Sub. No.	Position on ACP S= Support O = object N = Neutral	Summary of Submissions	Comment
1.	O.	<ul style="list-style-type: none"> Much better with Townsing Road included as verge upgrade on Townsing and North Lake and South Street would make the area look better over all. I'm all for support for the development of the area as we need it and future as land is hard to get with in 15 km of Perth ,tree line streets is a plus even up past my home in Townsing Road. Looks great height no problem higher the better at shopping centre ok. Would like my house in it. Best thing for this area let's make this area a buyers market. And remove the old stigma of this area needs new investment in area new family's Aldi chicken treat would be great with apartments there as well 20 stories not a issue this area so close to Murdoch hospital is great. And could see kardinya across to Applecross to Fremantle the new western suburbs style south of river. 	<ul style="list-style-type: none"> Noted. Submitter's property is at intersection of Bayliss Road and Townsing Road on western side of Bayliss. The submitter's property is within the 400m walkable catchment, however, the modified boundary is based on al

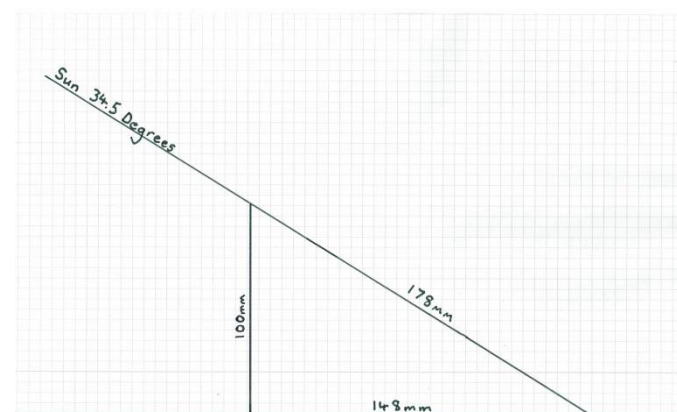
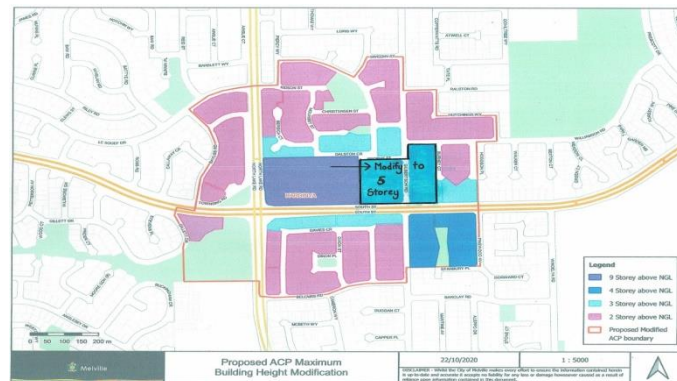
Upon reviewing the ACP map, we would like to **propose an amendment to the ACP boundary to reduce/modify the central district building height specifically upon the non-approved precinct area (from Aldi to Gilbertson Rd) to maximum 3 storeys** instead of the current proposed 9 storey height as per below image. This would greatly ease or reduce the significant negative impacts to residents especially affecting those residing directly adjacent South Street. Residents at 20 and 22 South St face North with full sunlight entering bedrooms and lounge areas 365 days a year and depend upon its energy for solar systems.

- **Overshadowing** (no access to sunlight over 50% of the year resulting in loss of PV, solar hot water thus increased utility costs, loss of health and amenities, inability to grow plants/garden). Currently the sun is at 34.5 degrees during Winter, Autumn to Spring at 58.5 degrees and Summer 81.5 degrees.
- **Loss of privacy**
- **Decreased property value**
- **Noise impacts from echoing** (significant increase and amplifying vehicle noise levels)
- **Storm Water congestion** (issue initially raised August 2020 and awaiting resolution)
- **Traffic congestion**
- **Scale and bulk** of proposed buildings incongruous with surrounding streetscape

We request further investigation and compliance to the specific related building codes we have identified (State Planning Policy 7.3):

O 2.2.4 The height of **development** recognises the need for **daylight** and **solar access** to adjoining and nearby residential development, **communal open space** and in some cases, public spaces.

O 2.7.3 **Buildings** are separated sufficiently to provide for residential **amenity** including visual and acoustic privacy, natural ventilation, sunlight and daylight access and outlook

O 3.2.2 Building form and orientation minimises overshadowing of the **habitable rooms, open space and solar collectors** of neighbouring properties during **mid-winter**.

O 3.5.1 The orientation and design of **buildings, windows and balconies** minimises direct overlooking of **habitable rooms** and private outdoor living areas within the **site** and of neighbouring properties, while maintaining **daylight** and **solar access**, ventilation and the external outlook of habitable rooms

Image above - An overlay showing the current Kardinya ACP proposed boundary (in green) and the proposed amended boundary (in purple) by the City of Melville (CoM). The CoM's proposal is not-supported.

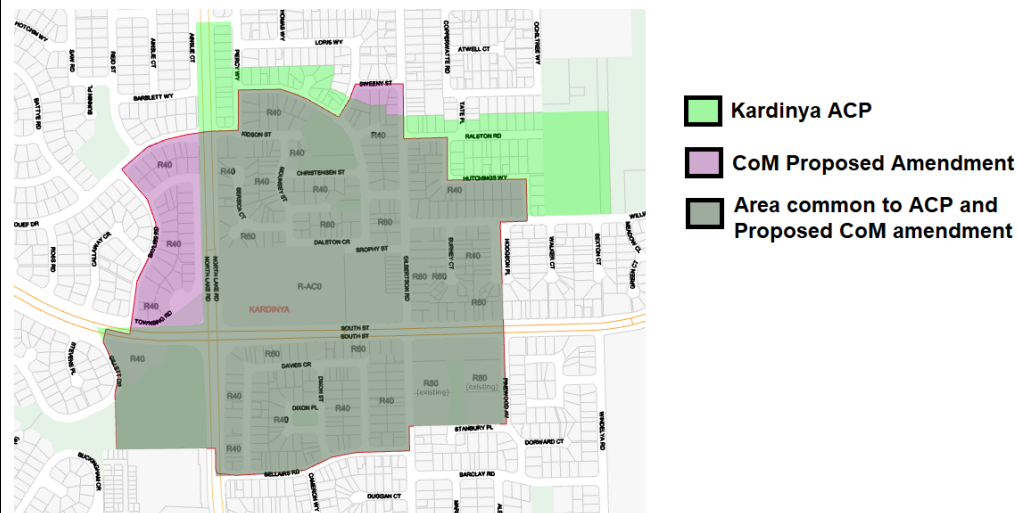
The proposed change of boundary is **strongly opposed**.

Image Above – CoM’s reasoning to amend the boundary – the circle indicates approx. 400m radius, which supposedly purports a ‘walking precinct’

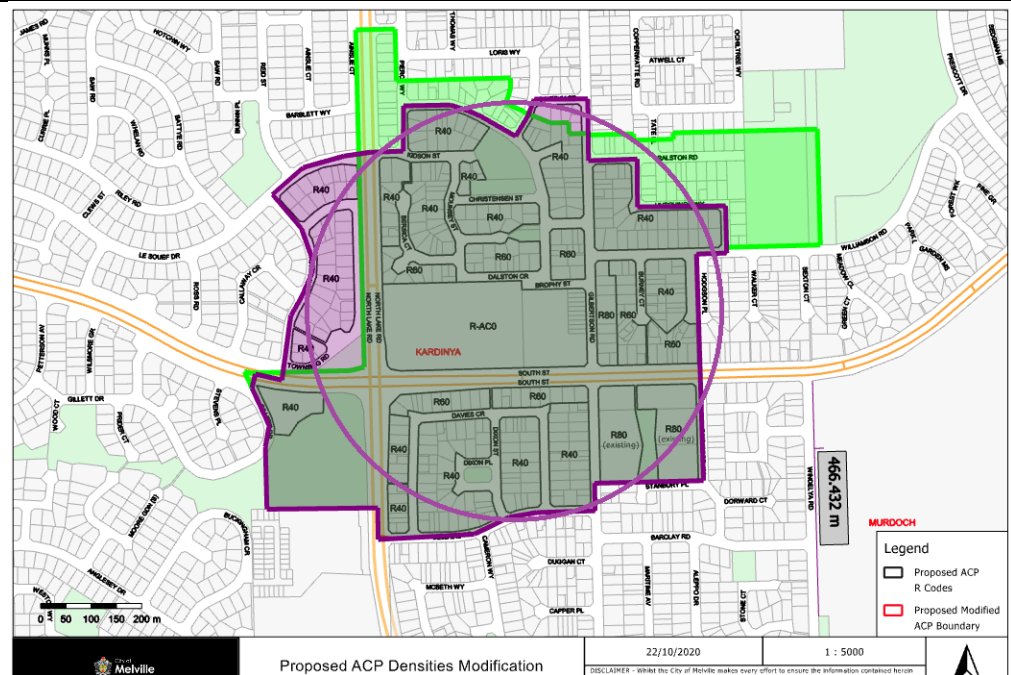
- In general, it appears the CoM's justification for changing the boundary of the ACP is the arbitrary 400m radius from the district centre, purporting a 5-minute walk. Assuming the radius has been taken from the central road located between the "frame and core", the depth of the CoM's consideration to the boundary is appears to represent simple circle, as purported on the image below.

- An arbitrary 400m radius has not simply been assumed as suggested by the submitter. The City has undertaken a 400m walkable assessment based on clear pedestrian routes including streets, pedestrian rights of way and controlled pedestrian crossings across major roads. In addition, the modified boundary reflects the preferred approach of providing the transition between changes in density wherever possible to along streets rather than along property boundaries to minimize potential impacts on abutting properties, therefore the boundary is initially based upon the walkable catchment extent and then tweaked to run where possible along streets.

Image above – 400m radius, discounted by circa 80m to the South and West (on account of major road crossings) and increased by 80m to the north and east to offset. Central point over Gilbertson Road.

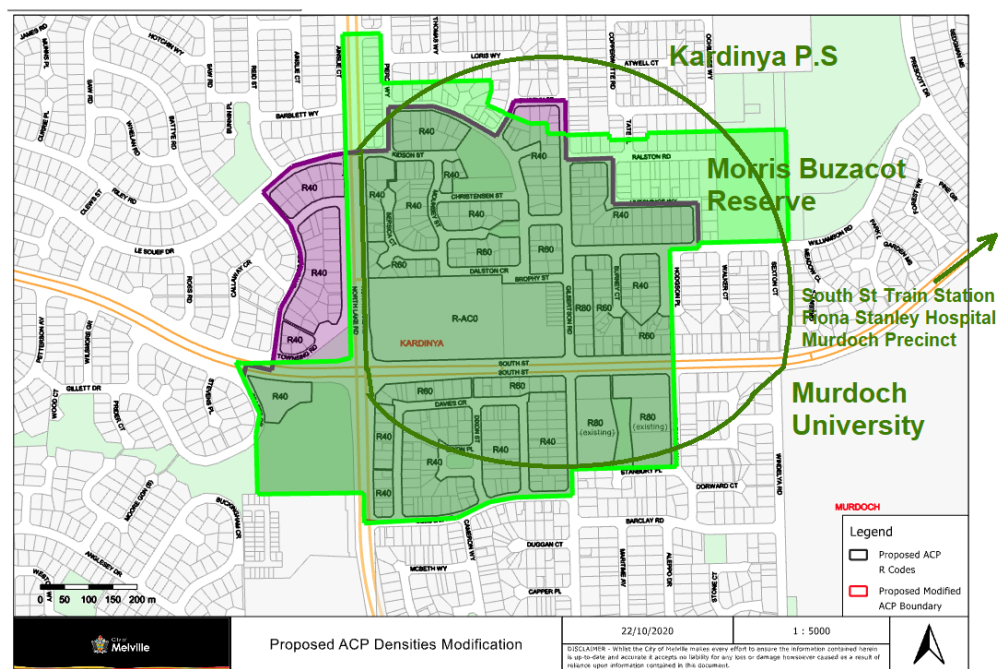
- As mentioned above, it was assumed the internal road between the frame and core was the centre-point for the radius, however given the major road barriers to the west and south of the proposed Activity Centre Plan (ACP), it would make more practical sense to offset the central point of the ACP on Gilbertson road. After all, the City of Melville has also proposed mixed commercial use on Gilbertson road which will include potential cafés, medical centres, etc, which are all businesses more likely to be ‘walked-to’.
- Noting the above, if the 400m radius is reduced by 80m to the south and west (on account of waiting at least 1 minute to cross the major roads, not accounting for the walk to get to a safe signalised location to cross) and extended by 80m to the north and east to recompensate, the boundary would resemble the following.

- The above demonstrates that extension to the east should be promoted. It is a far safer precinct in regard to walking and it provides better proximity to infrastructure such as a primary school, university, public green space and the Murdoch precinct. Those factors will also promote desirability for the area which will attract families, workers, and students.

Image above – Potential revised boundary focusing on the eastward extension, bringing more adjacent infrastructure to the Activity Centre

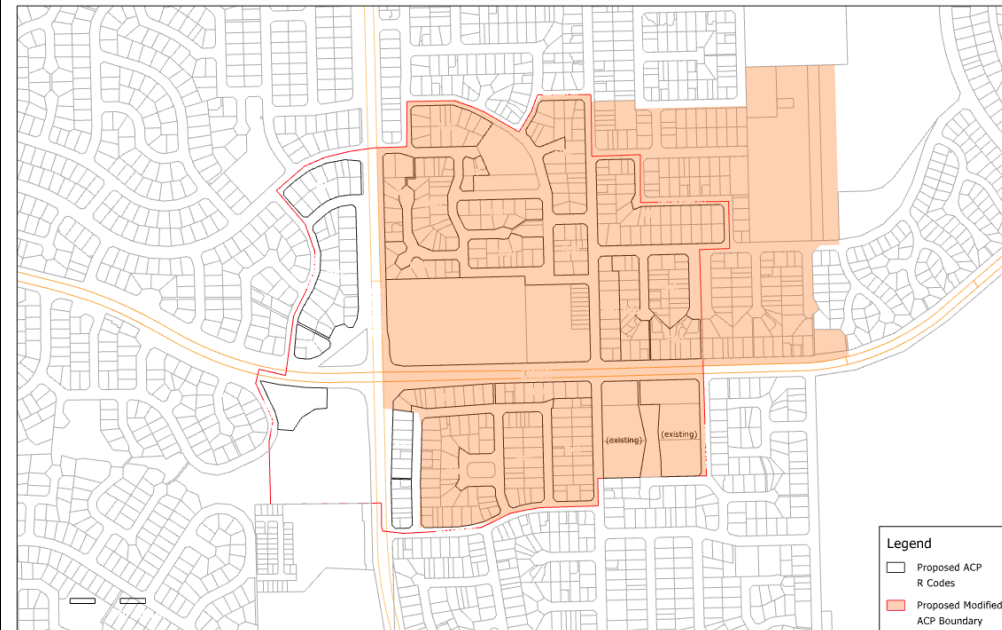
- The above proposal brings adjacent infrastructure to ACP, including Kardinya Primary School, Murdoch University and Morris Buzacott Reserve. It also removes the safety hazard associated with crossing North Lake Road. The portion of the ACP boundary on the southern side of South Street will utilise either the Gilbertson Road signalised intersection or the South Street/Main Street signalised intersection. Both of these traffic signals are addressed in existing ACP proposal. Students and staff heading east toward Murdoch University and Fiona Staley can utilise an underpass which already exists.

The above image overlays shows the potential R-Coding based on the revised proposed boundary discussed earlier in this document

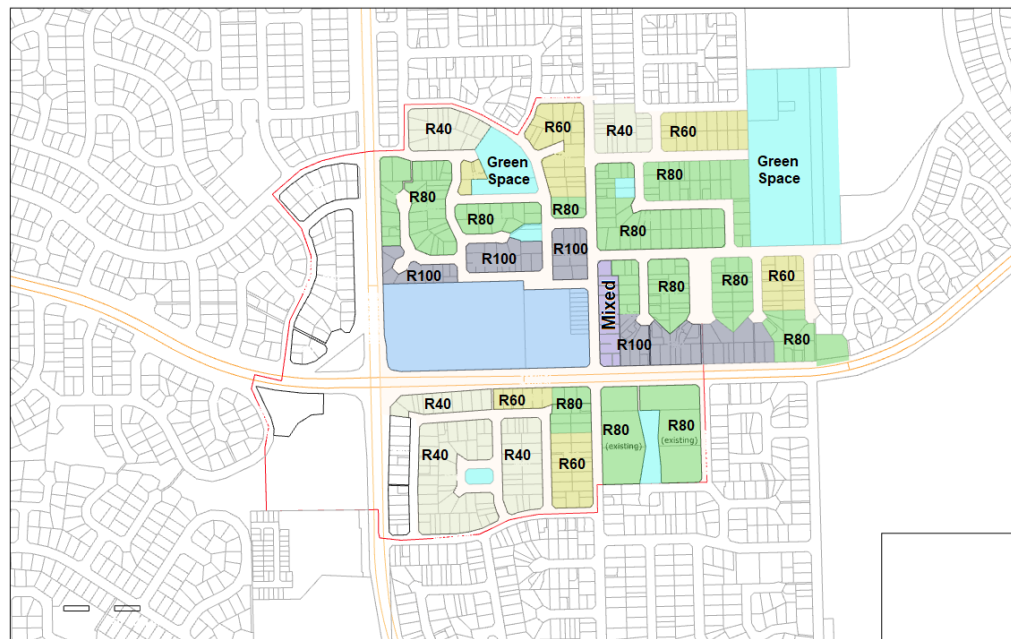
The proposed R-Coding below is based on the proposed revised ACP boundary discussed earlier in this document. It creates a precinct with better density in the corridor to the east along South Street and north-east toward the Green Space and Primary School.

- During advertising of the proposed modifications to the ACP, 10 submissions have been received from the subject area. All object to the proposals contained in the modified ACP with this submitter and one other objecting on the basis that they do not support the removal of their properties from the ACP area as a consequence of the modification to the boundary. It is noted, however, that all the other objections were on the basis that the proposed modified ACP should be adjusted to further reduce heights and density. Again given this it can be anticipated that there would be substantial opposition to the proposals outlined in this submission.
